Statement of Evidence

Reference: Macquarie Point Multi-Purpose Stadium Project Of
State Significance Integrated Assessment Process

Author: Dr Neil Mackenzie

Date: 18 June 2025

Figure 15-6 Crowd movement study

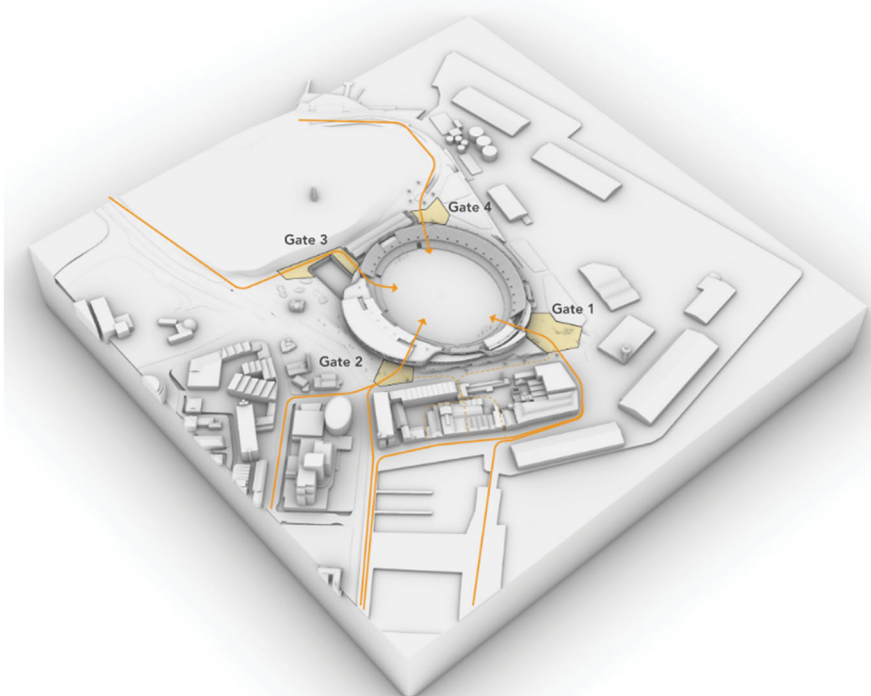
- Noise levels from patrons arriving/departing the stadium have been estimated by AECOM as 25-28dBA, noting that a pedestrian movement study (refer to Figure 15-6 from Appendix B “Stadium Design Description” [Ref. 14.4] does not show patrons passing through the Wapping area, but rather along the State Roads. This level would not be intrusive given it is less than the existing background noise level in the environment.

Figure 15-7 Proposed Redevelopment of Macquarie Point Wharf

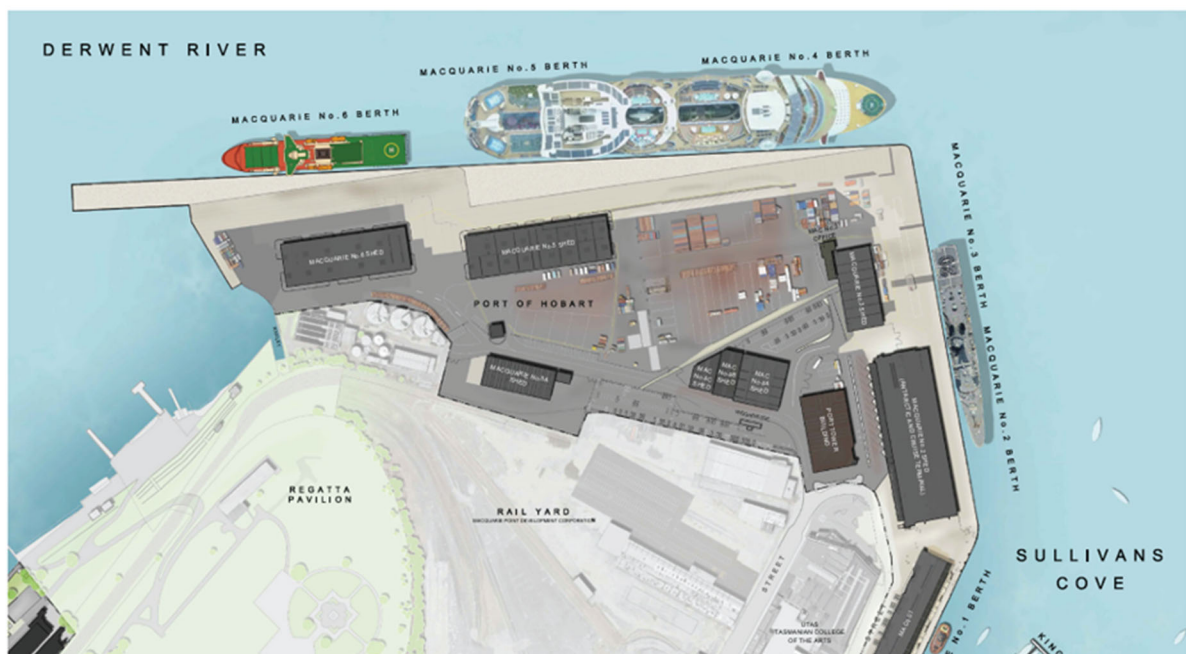
Figure 15-7). I am not aware of a construction schedule for the proposed redevelopment (other than a tender call for a construction partner for Wharf 6 issued 2 April 2025), hence I am unable to comment on the need to consider cumulative noise impacts.

Figure 22-3 Noise reduction comparison between single facade and double facade for Sullivans Cove Apartments

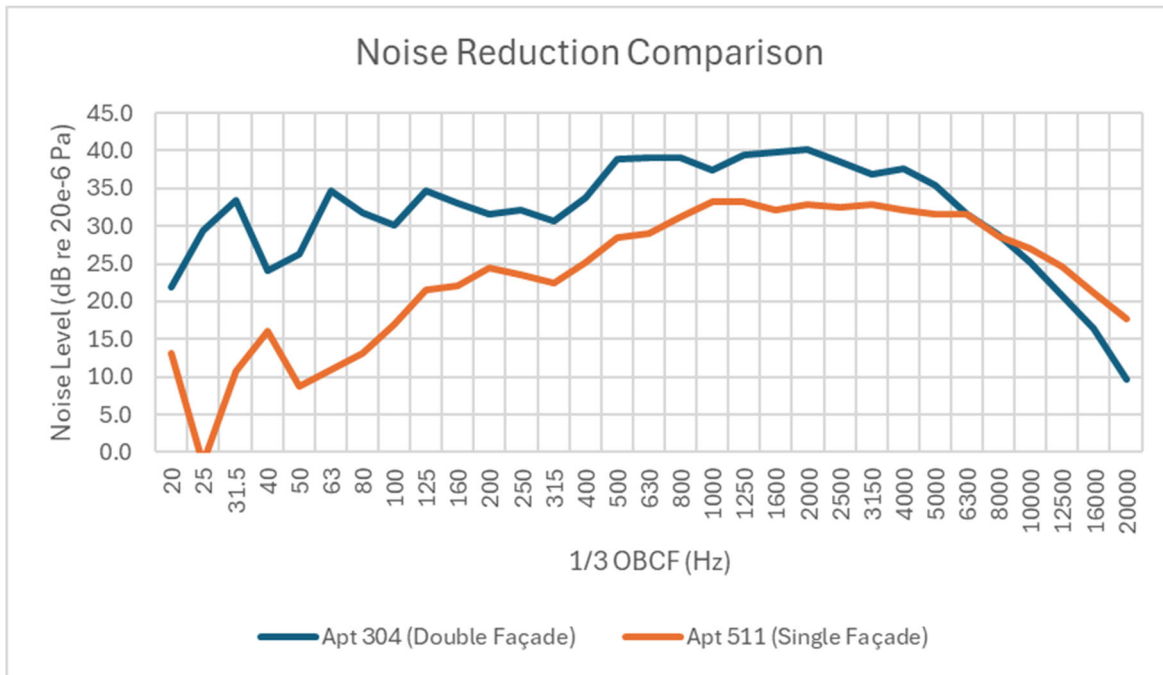
- As shown in Figure 22-3, the noise reduction provided by the double facade is significantly greater (by about 20dB at low frequencies, less than 125Hz) and greater (by about 10dB) than the single facade, with the average noise reduction about 35dBA (across all frequencies).
